ADDENDUM NO. 1  
Bid Due Date: 7/20/23

Description: Richmond Library Roof Systems Replacement

**ROOF SYSTEM REPLACEMENT ~~CONSTRUCTION DOCUMENT SUBMISSION~~ ISSUED FOR  
BID**  
**RICHMOND LIBRARY** **ADDENDUM 1**  
**DIGROUP ARCHITECTURE** **Issued: JULY 13, 2023**

Sheet Name:  
**EXTERIOR PHOTOS, MASONRY DETAILS AND NOTES**

Sheet No:  
**A-103**  
Sheet 5 of 6

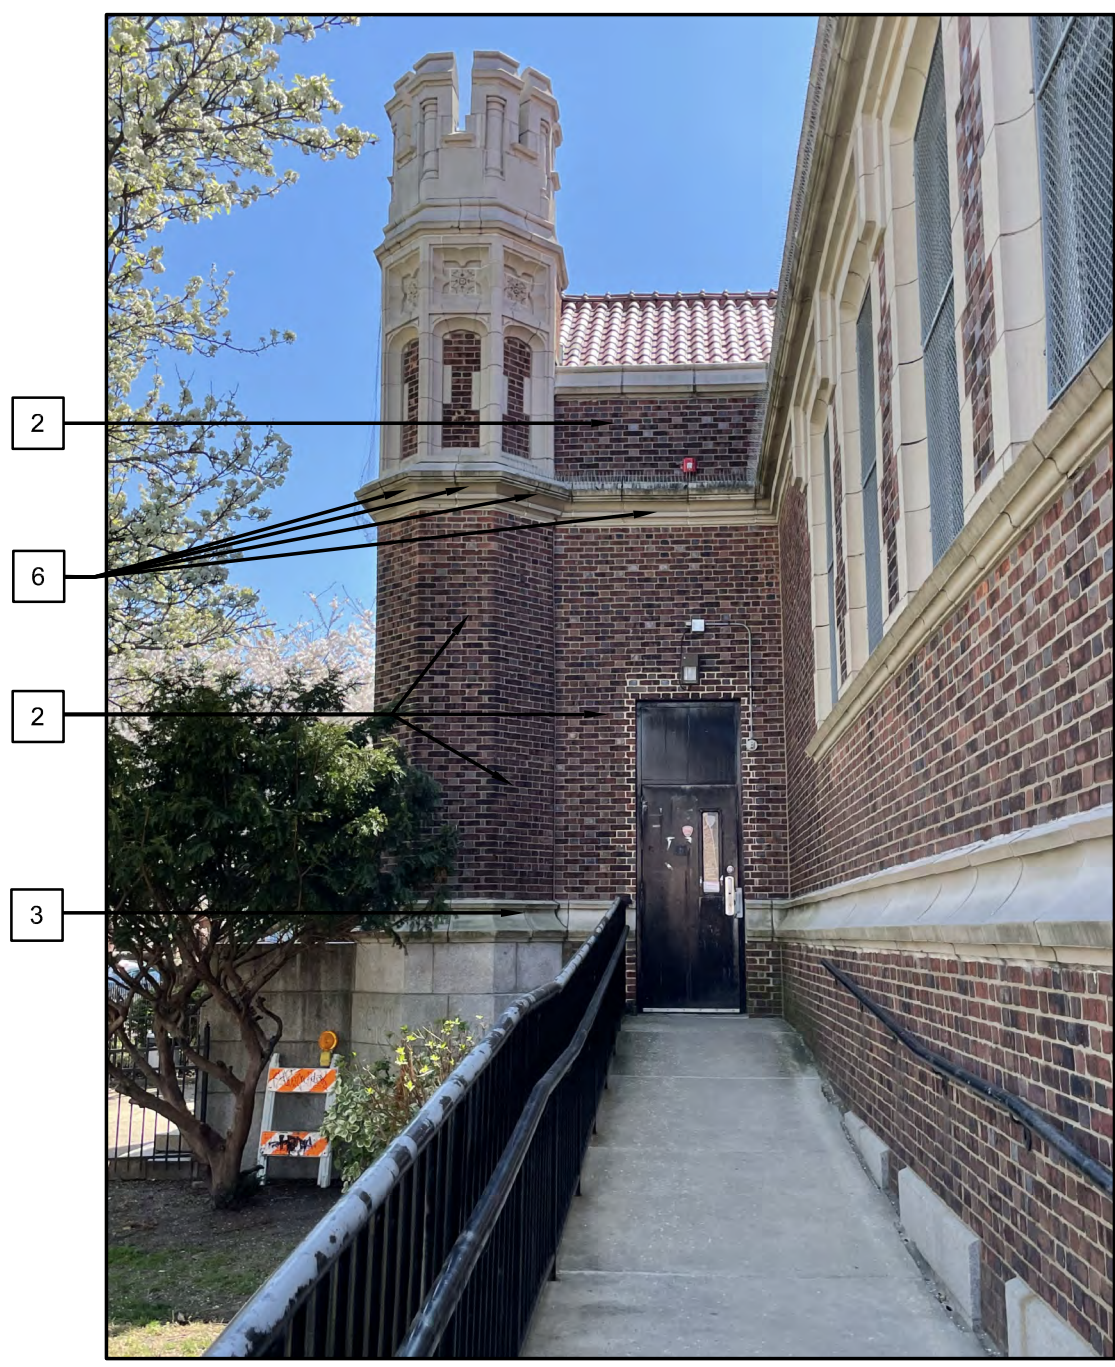
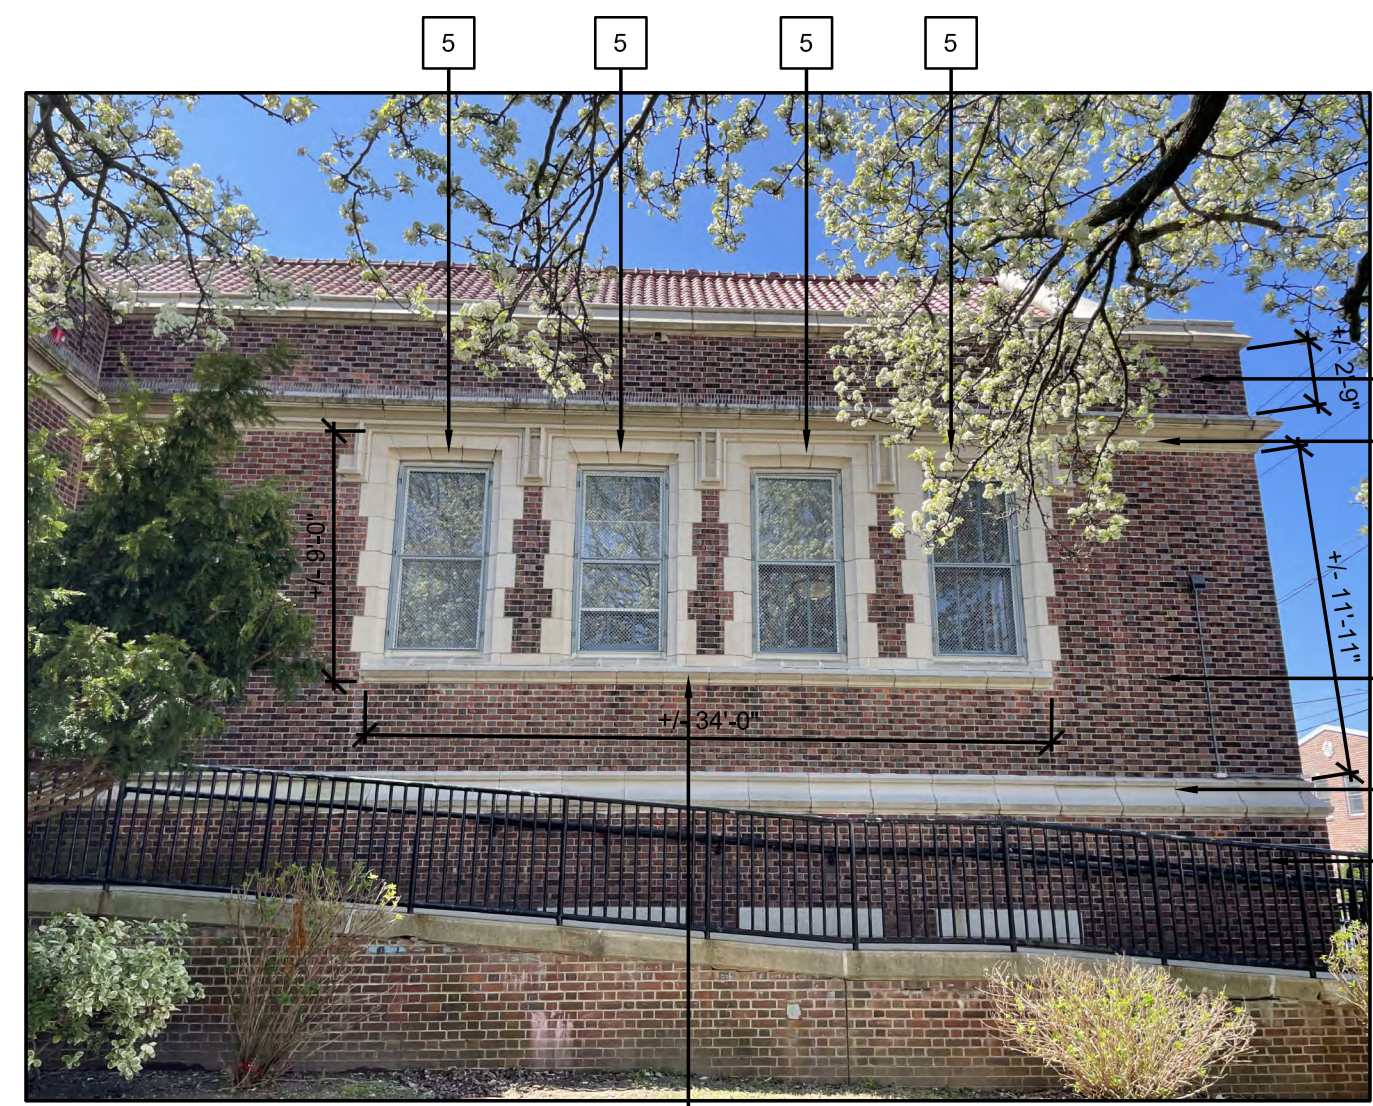
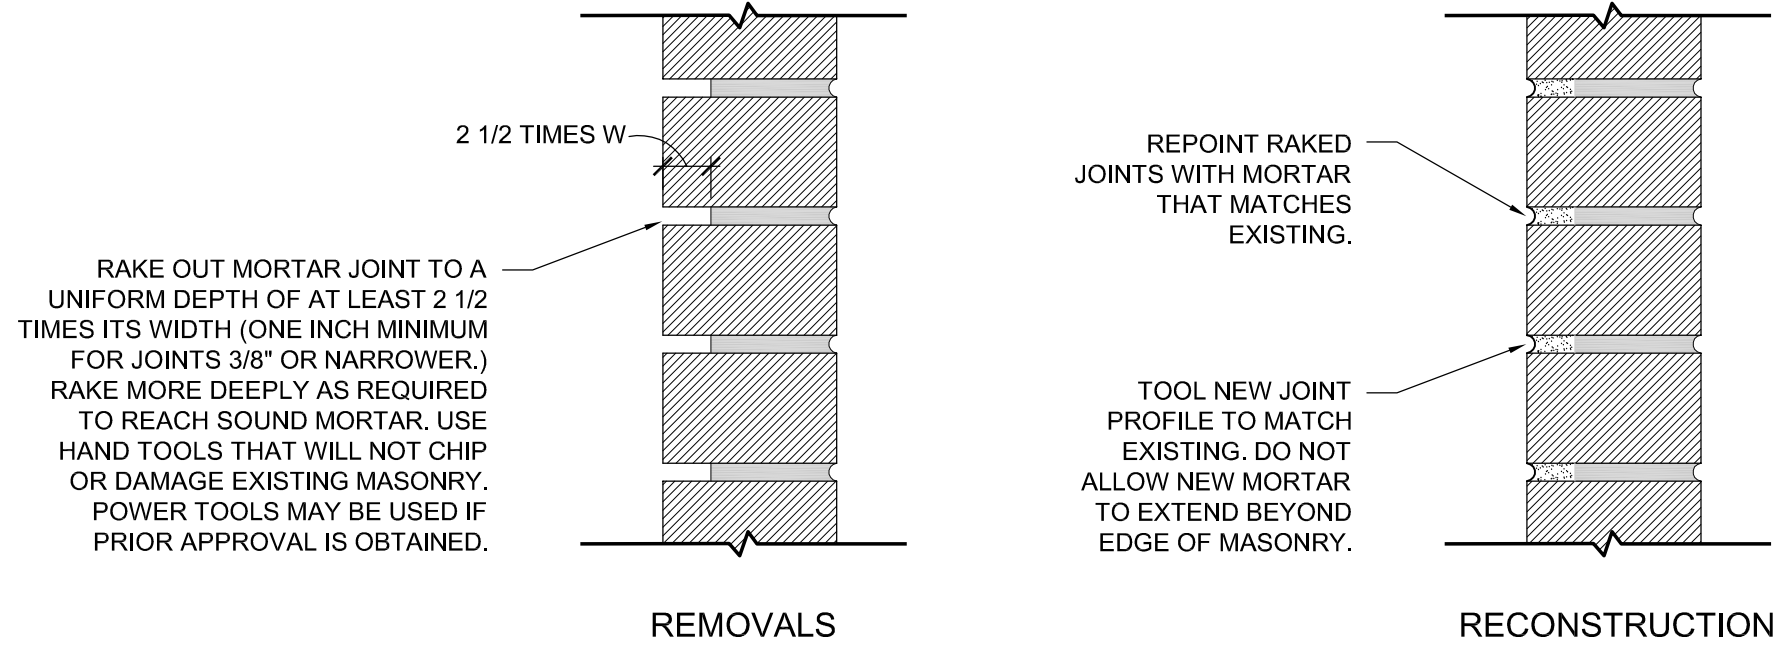
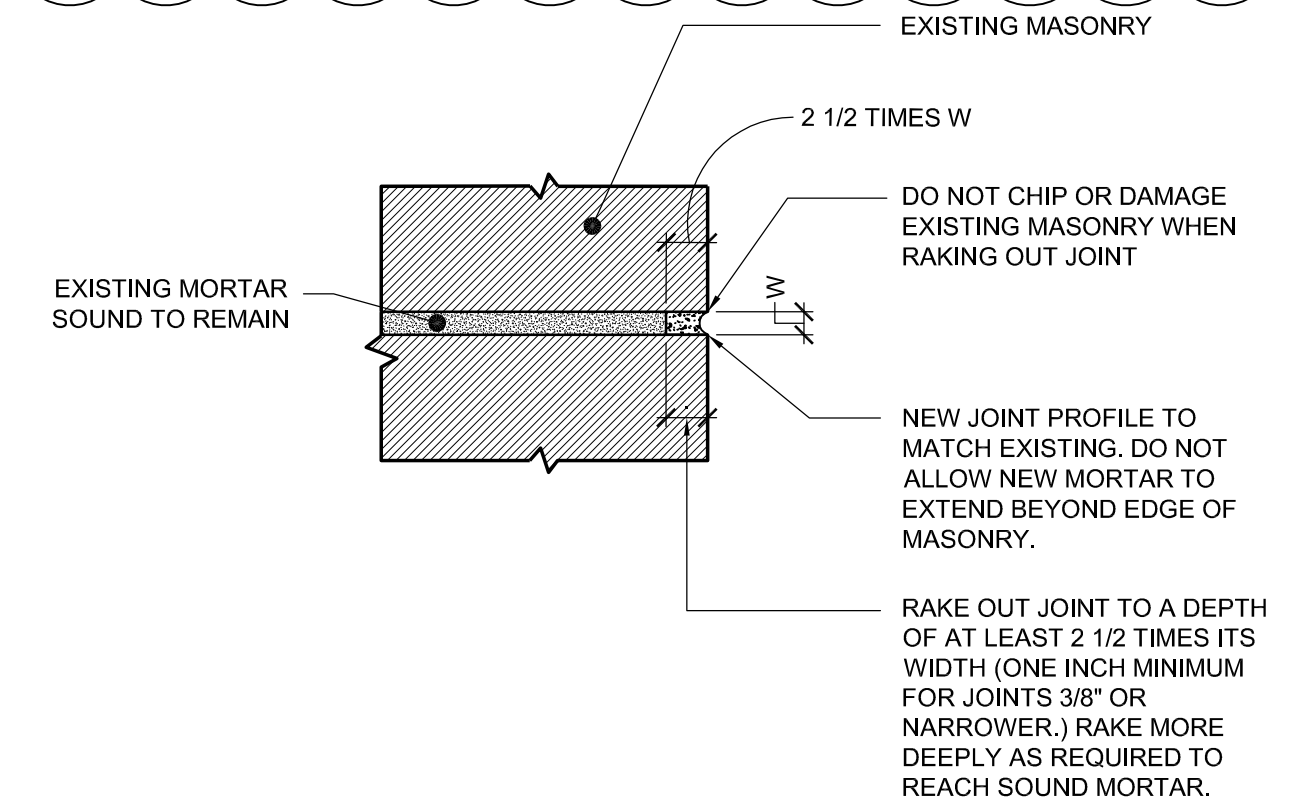
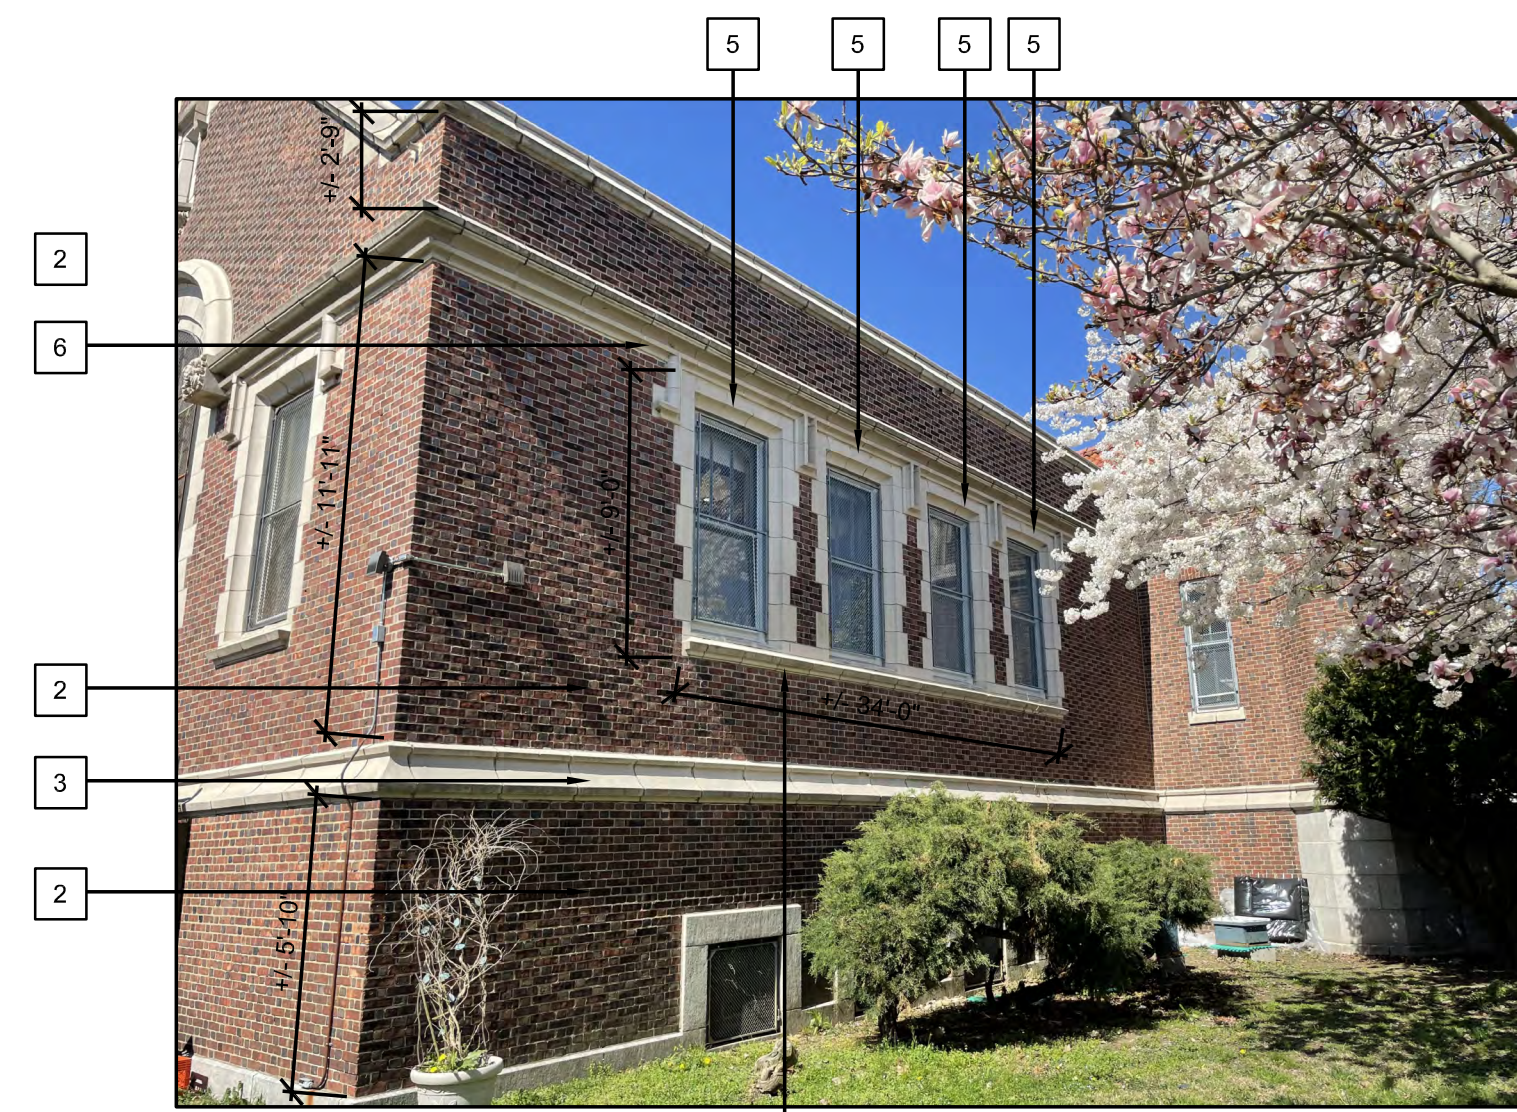
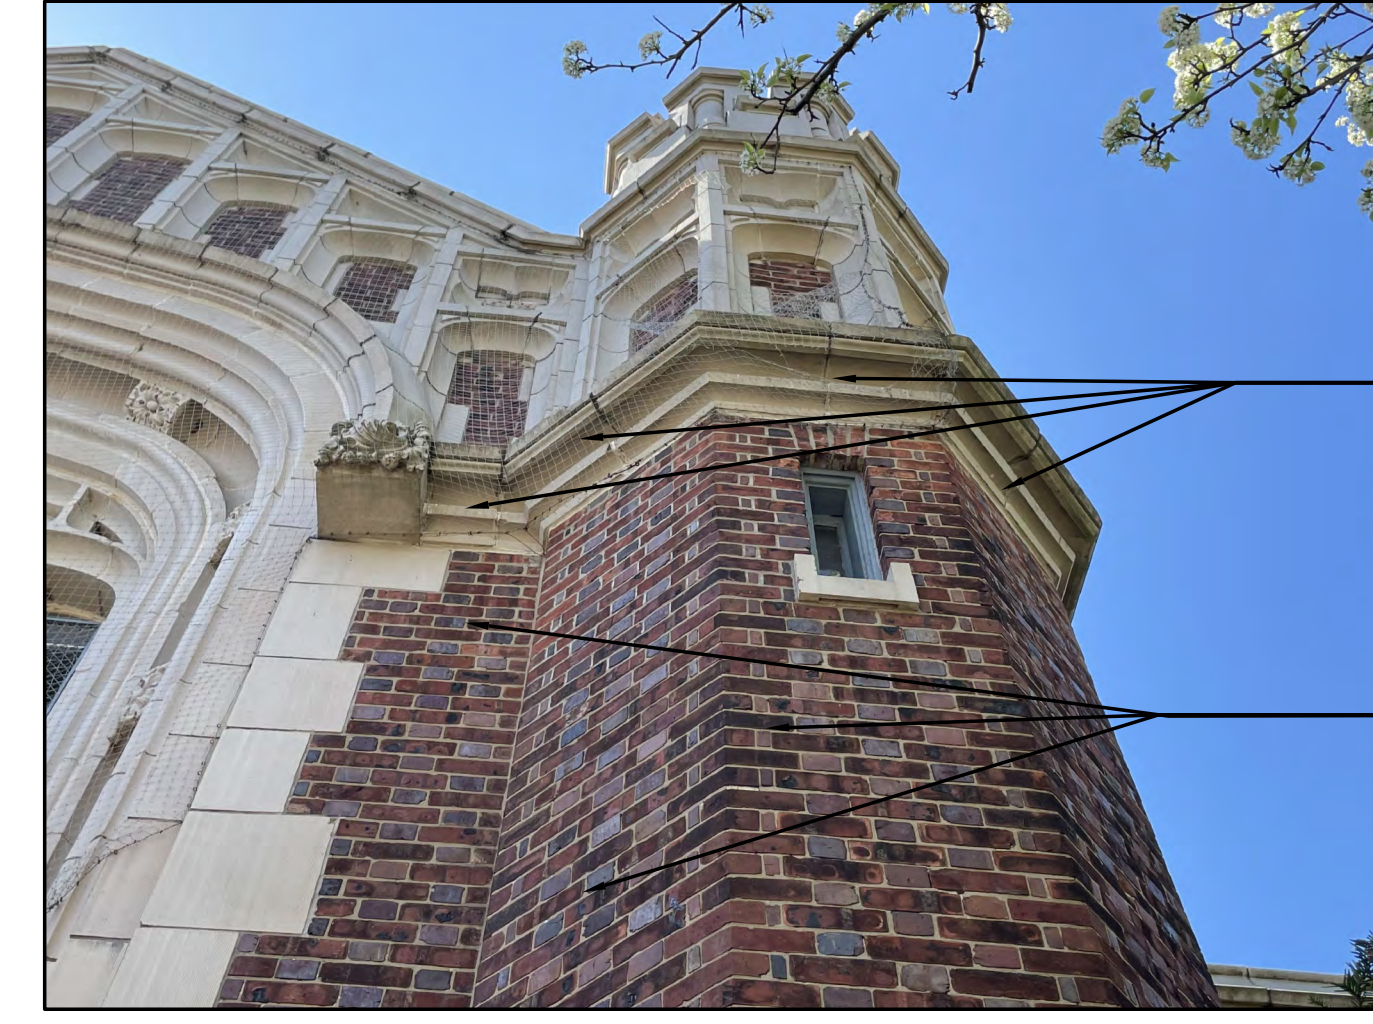
6. Remove Drawing A-103, EXTERIOR PHOTOS, MASONRY DETAILS, AND NOTES and Replace with attached Drawing A-103, EXTERIOR PHOTOS, MASONRY DETAILS, AND NOTES and.

- 1 BASE BID: RAKE AND REPOINT BRICK MASONRY OF CHIMNEY IN ITS ENTIRETY. (ALL FOUR SIDES) SEE DETAILS 3/A-103 AND 4/A-103 FOR ADDITIONAL INFORMATION.
- 2 ALTERNATE BID #2: RAKE AND REPOINT 100% BRICK MASONRY. SEE DETAILS 3/A-103 AND 4/A-103 FOR ADDITIONAL INFORMATION.

- 3 ALTERNATE BID #1: RAKE AND REPOINT ALL TERRA COTTA BAND JOINTS INCLUDING CONTINUOUS TOP AND BOTTOM JOINTS. SEE DETAILS 3/A-103 AND 4/A-103 FOR ADDITIONAL INFORMATION.

- 4 ALTERNATE BID #1: RAKE AND REPOINT ALL TERRA COTTA WINDOW SURROUNDS INCLUDING CONTINUOUS TOP AND BOTTOM JOINTS. SEE DETAILS 3/A-103 AND 4/A-103 FOR ADDITIONAL INFORMATION. CAREFULLY REMOVE AND STORE WINDOW SECURITY GRILLS AND REINSTALL FOLLOWING THE COMPLETION OF MASONRY WORK.

- 5 ALTERNATE BID #1: RAKE AND REPOINT ALL TERRA COTTA ENTRANCE SURROUNDS. SEE DETAILS 3/A-103 AND 4/A-103 FOR ADDITIONAL INFORMATION.
- 6 ALTERNATE BID #1: RAKE AND REPOINT ALL TERRA COTTA COURNICHE INCLUDING CONTINUOUS TOP AND BOTTOM JOINTS. SEE DETAILS 3/A-103 AND 4/A-103 FOR ADDITIONAL INFORMATION.

- 7 ALTERNATE BID #1: RAKE AND REPOINT ALL TERRA COTTA ENTRANCE SURROUNDS. SEE DETAILS 3/A-103 AND 4/A-103 FOR ADDITIONAL INFORMATION. REMOVE EXISTING BIRD NETTING. INSTALL NEW BIRD NETTING TO MATCH EXISTING ONCE MASONRY WORK HAS BEEN COMPLETED.

- 8 ALTERNATE BID #1: RAKE AND REPOINT ALL TERRA COTTA AND LIME STONE ENTRANCE SURROUNDS. SEE DETAILS 3/A-103 AND 4/A-103 FOR ADDITIONAL INFORMATION.
- 9 BASE BID: CLEAN SURFACE OF MASONRY CHIMNEY CAP. RAKE AND REPOINT MASONRY JOINTS OF CHIMNEY CAP AND ROUND FLUE. PROVIDE AND INSTALL NEW +/- 17"x21" (VERIFY AND COORDINATE SIZE OF CAP WITH EXISTING CHIMNEY FLUE) 304 STAINLESS STEEL TOP MOUNTED MESH FLUE CAP.
